ABB	Technical Notice		2NAA000105	
Responsible department: ELDS/ Service	Date: 22.10.2019	File No.: Replacement of obsolete MCU (1SCA022657R8610 & 1SCA022657R8950)	Revision index: B	
Prepared by: Hendry Evan	Checked by: Hendry Evan	Approved by: Marco Egman	Valid for: INSUM 2	Page 1/4

INSUM 2

Replacement of obsolete MCU (1SCA022657R8610 & 1SCA022657R8950)

Figure 1 INSUM 2 MCU with VU Hardware

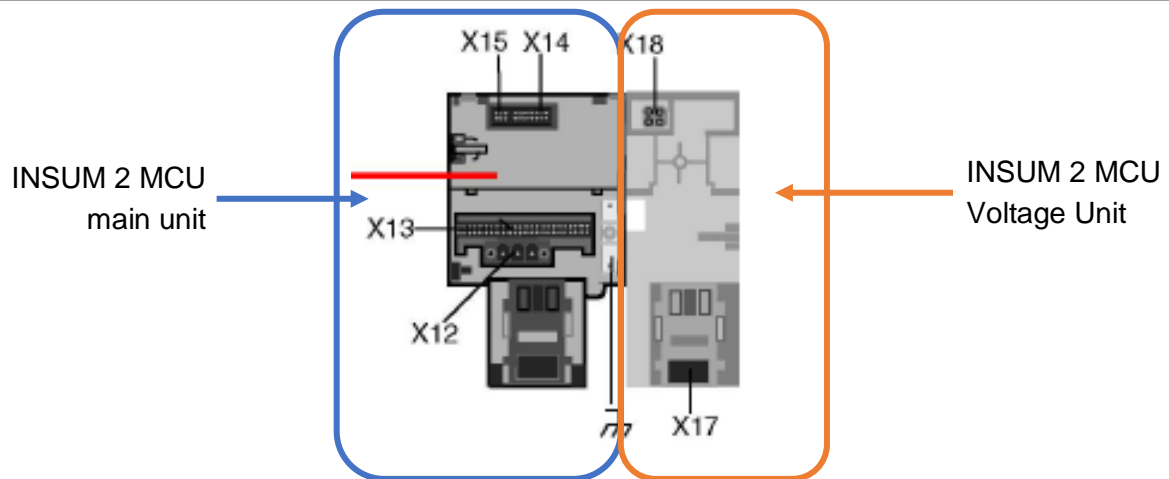
The voltage monitoring is handled in a separate hardware called as the voltage unit. The voltage unit has terminal X17 and X18 which is used for monitoring the voltage and power supply respectively.

For replacement of 1SCA022657R8610 (MCU2A01C0-4) and 1SCA022657R8950 (MCU2A02C0-4) , the 1SCA022657R8790 (MCU2A01V2-4) and 1SCA022657R9090 (MCU2A02V2-4) can be used respectively by not using/connecting the voltage unit.
